# Groundwater Application Review Summary Form

Application # G- 19460

# PUBLIC INTEREST REVIEW FOR GROUNDWATER APPLICATIONS

**A. GENERAL INFORMATION:** Applicant's Name: Clearlake Farms, LLC County: Marion

**Theis Interference Analysis-POA 1/Johnson Well (MARI 17388) and MARI 5080**

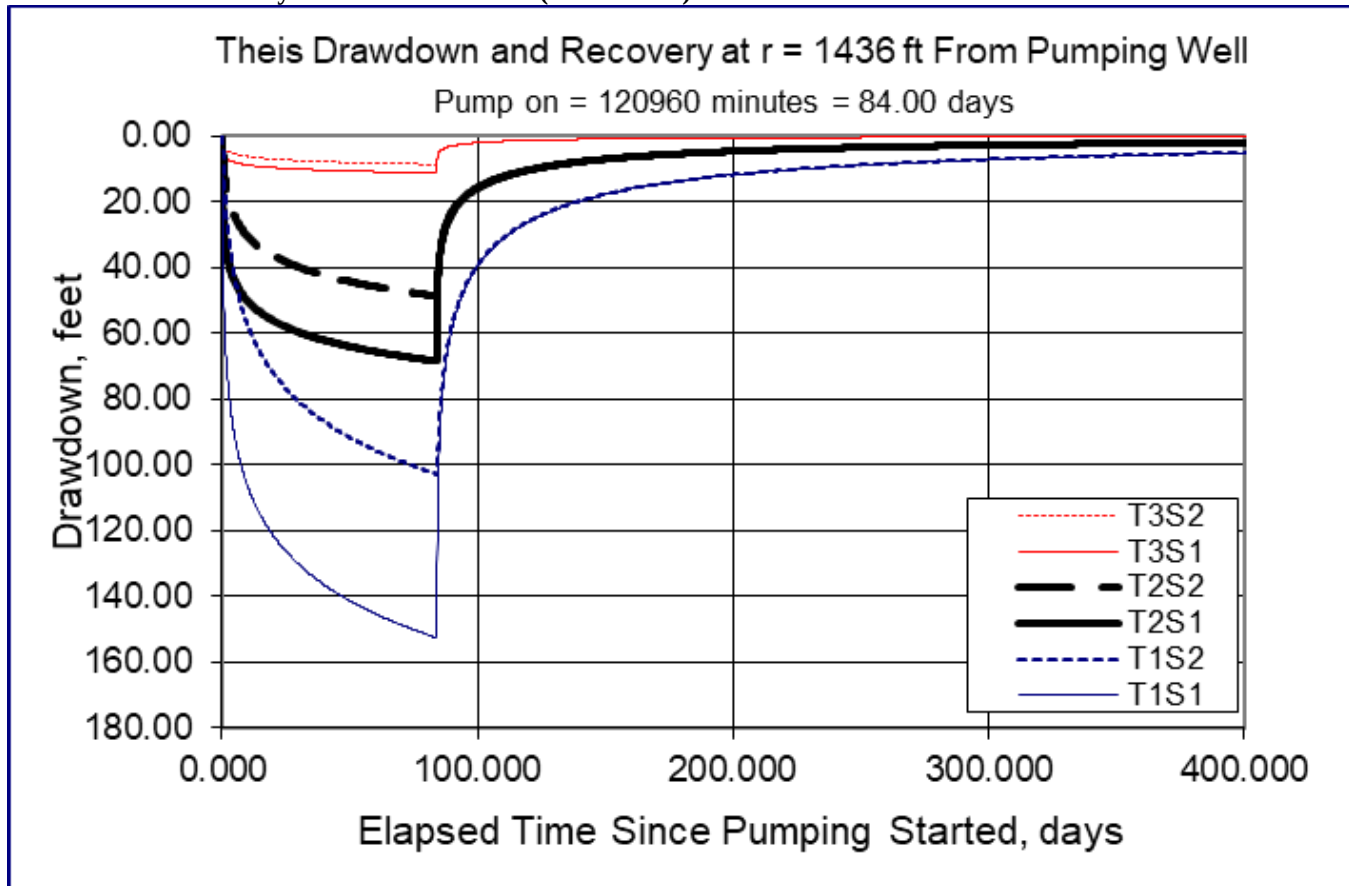
Water levels are stable (see Water Level Measurements in Nearby Wells). Of the eleven observation wells within one-and-a-half miles of the POAs, four have records over the last five years: MARI 17269, MARI 68355, MARI 58798, and POA 1/MARI 17388. A couple of observation wells show declines between 20 and 30 years ago, however, more recent measurements indicate recovery of water levels since then. There are 57 POAs for 63 groundwater rights within one mile of the POAs, however, the overall steady water levels described above indicate that there is a low likelihood of interference with other groundwater users. The groundwater resource is not likely over-appropriated.  
The nearest groundwater user to POA 1/Johnson Well (MARI 17388) is MARI 5080 (a POA on Claim GR 3285 with priority date 4/30/1950), located 556 ft southeast and at an elevation of 182 ft amsl. It is likely the proposed use would cause some degree of well-to-well interference with MARI 5080. To assess the degree of drawdown, a Theis drawdown analysis was conducted for the proposed use (see attached Theis Drawdown Analysis). Results indicate that the proposed use is likely

**to cause well-to-well interference with MARI 5080 that exceeds the threshold under the standard condition for alluvial aquifers in the Willamette Basin. Therefore, the proposed use is not in the capacity of the resource.**

**Theis Interference Analysis-POA 2/Main Well (MARI 5169) and MARI 5110**

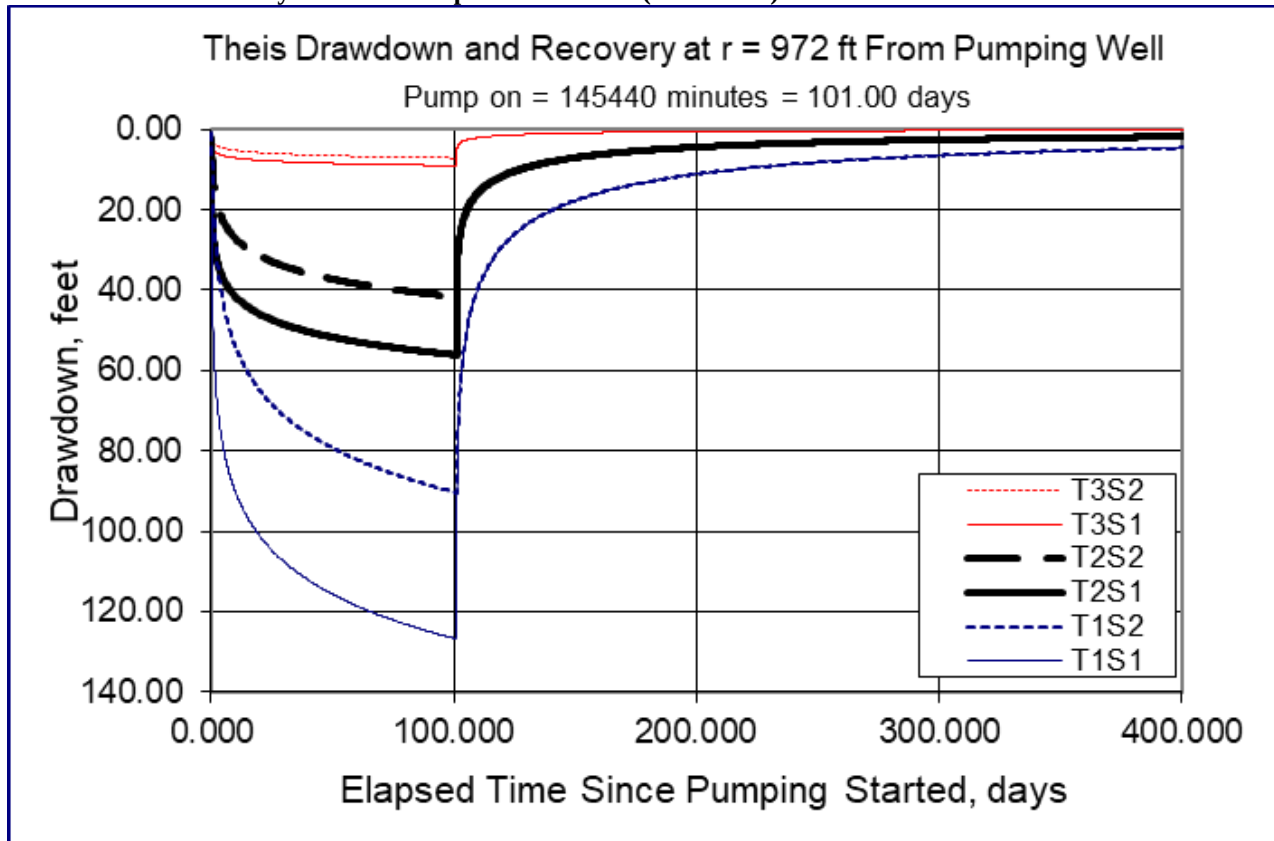
The nearest groundwater user to POA 2/Main Well (MARI 5169) is MARI 5110 (a POA on Certificate 55417 with priority date 6/13/1983), located 1,436 ft southeast and at an elevation of 177 ft amsl. It is likely the proposed use would cause some degree of well-to-well interference with MARI 5110. To assess the degree of drawdown, a Theis drawdown analysis was conducted for the proposed use (see attached Theis Drawdown Analysis). **Results indicate that the proposed use is likely to cause well-to-well interference with MARI 5110 that exceeds the threshold under the standard condition for alluvial aquifers in the Willamette Basin. Therefore, the proposed use is not in the capacity of the resource.**

**Theis Interference Analysis-POA 3/Proposed New Well (PROP 600) and MARI 71298**

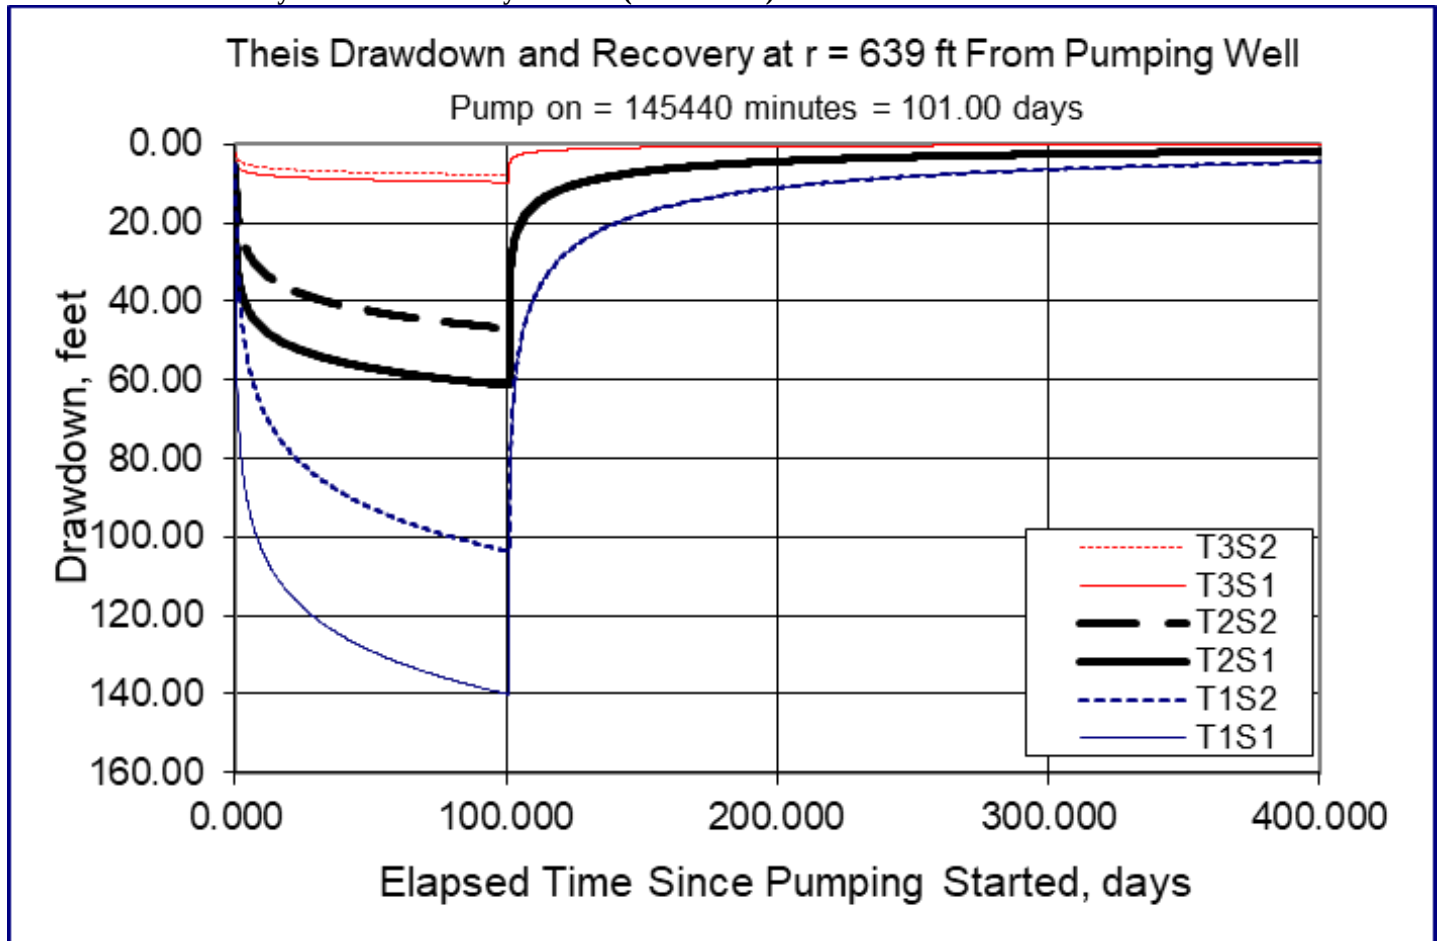
The nearest groundwater user to POA 3/Proposed New Well (PROP 600) is MARI 71298 (an exempt domestic well) located 972 ft southwest and at an elevation of 184 ft amsl. To assess the degree of drawdown, a Theis drawdown analysis was conducted for the proposed use (see attached Theis Drawdown Analysis). **Results indicate that the proposed use is likely to cause well-to-well interference with MARI 71298 that exceeds the threshold under the standard condition for alluvial aquifers in the Willamette Basin. Therefore, the proposed use is not in the capacity of the resource.**
